April 2018
FL750AB

Emissions Recall: Ambient Air Temperature Sensors

Models Affected: Specific Freightliner 122SD and Western Star 4700/4900 model vehicles manufactured January 4, 2016, through May 6, 2016, with certain Detroit engines and West Coast style side mirrors.

Fig. 1, Vehicle Door and Mirror Assembly

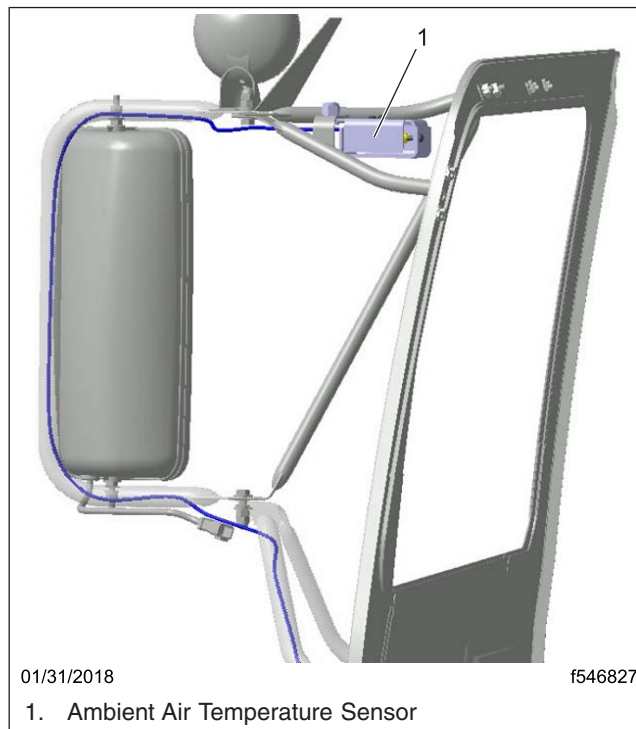
1. Check the base label (Form WAR259) for a completion sticker for FL750 (Form WAR260) indicating this work has been completed. The base label is usually located on the passenger-side door, about 12 inches (30 cm) below the door latch. If a completion sticker is present, no work is needed. If a completion sticker is not present, proceed to the next step.
2. Park the vehicle, shut down the engine, and apply the parking brakes. Chock the tires.
3. Remove the two screws from the sensor cover, and remove the cover. See [Fig. 1](#).

4. Inspect the sensor for the correct part number, **DDE 23518328**.

If the part number is NOT correct, proceed to the next step.

If the part number IS correct, the repair is finished. Clean a spot on the base label (Form WAR259). Write the campaign number, FL750, on a blank red completion sticker (Form WAR260) to indicate the work has been completed and attach it to the base label.

5. Remove the two nuts securing the sensor.
6. Disconnect the sensor.
7. Position the new sensor on the vehicle.
8. Install the mounting nuts, and tighten the nuts securely.
9. Position the cover over the sensor, and install the two mounting screws. Tighten the screws securely.
10. Clean a spot on the base label (Form WAR259). Write the campaign number, FL750, on a blank red completion sticker (Form WAR260) to indicate the work has been completed and attach it to the base label.
